UPDATE CHANGE NOTIFICATION # 16512Generic Copy

Issue Date: 27-Oct-2011**TITLE:** Update Notification to Qualification of Additional Fab and Assembly Source for CM1213A-04SO, CM1293A-04SO**PROPOSED FIRST SHIP DATE:** 27-Oct-11**AFFECTED CHANGE CATEGORY(S):** Change to the Description and Purpose (Addendum)**ADDITIONAL RELIABILITY DATA:** Available
Contact your local ON Semiconductor Sales Office or Laura Rivers <laura.rivers@onsemi.com>**SAMPLES:** Contact your local ON Semiconductor Sales Office**FOR ANY QUESTIONS CONCERNING THIS NOTIFICATION:**
Contact your local ON Semiconductor Sales Office or Jill Daugherty <jill.daugherty@onsemi.com>**NOTIFICATION TYPE:**

This is an update to FPCN16512 submitted on 08/12/2010 to notify customer on the change in schematic diagram. Please refer to addendum below:

Marking change:

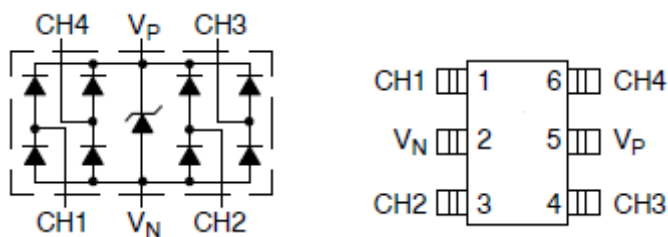
CM1213A-04SO: marking will change from “D234” to “234”
 CM1293A-04SO: marking will change from “D635” to “635”

Pre-Change Schematic

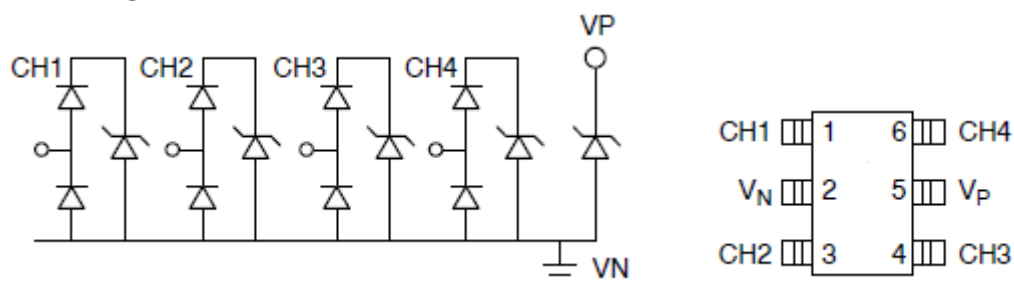
In order to facilitate certain parametric improvements during the transfer a change was made in the part schematic (shown below). This change is transparent in the performance of the part in the intended application, and the device pin out remains the same. However, the change may be noted during pin to pin ICT testing.
